Strathfield Local Planning Panel Meeting

Thursday, 5 September 2019

TO: Strathfield Local Planning Panel Meeting - 5 September 2019
REPORT: SLPP – Report No. 1
SUBJECT: DA2019/064 - 12 THERRY STREET EAST STRATHFIELD SOUTH
 LOT 2 & 3 DP 207560
DA NO. DA2019/064

Proposal:	Demolition of existing structures and construction of a pair of semi-detached dwellings and boundary adjustment.
Applicant:	Mounir El-Kaderi
Owner:	JST Wong & SP Hong
Date of lodgement:	02/05/2019
Notification period:	10/05/2019 – 24/05/2019
Submissions received:	One (1)
Assessment officer:	PF
Estimated cost of works:	\$810,273
Zoning:	R2 Low Density Residential - SLEP 2012
Heritage:	<ul style="list-style-type: none"> The site is not a heritage item or located within a heritage conservation area (SLEP 2012) The site is located in the vicinity of listed items (St Anne’s Church, Sydney Water Pressure Tunnel).
Flood affected:	No
Cl. 4.6 variation request:	Yes – 46.9% variation sought to the <i>minimum subdivision lot size</i> development standard (Clause 4.1 SLEP 2012).
Cl. 4.6 supported:	No
Peer review of Cl. 4.6:	<ul style="list-style-type: none"> Peer review of Clause 4.6 written request undertaken. Recommendatio

Figure 6. Supplied ‘Streetscape Analysis’ (Source: Drawing No. 12, Issue 02, dated 8/06/2019, prepared by Elkad Group Pty Ltd).

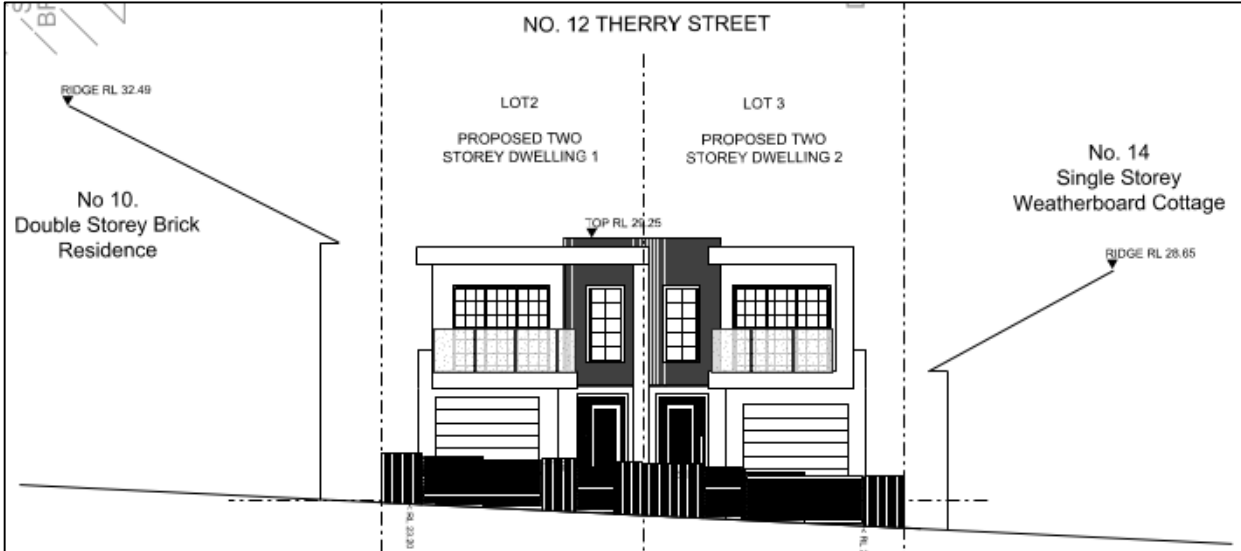
A streetscape analysis has been submitted by the applicant and is shown at **Figure 6**.
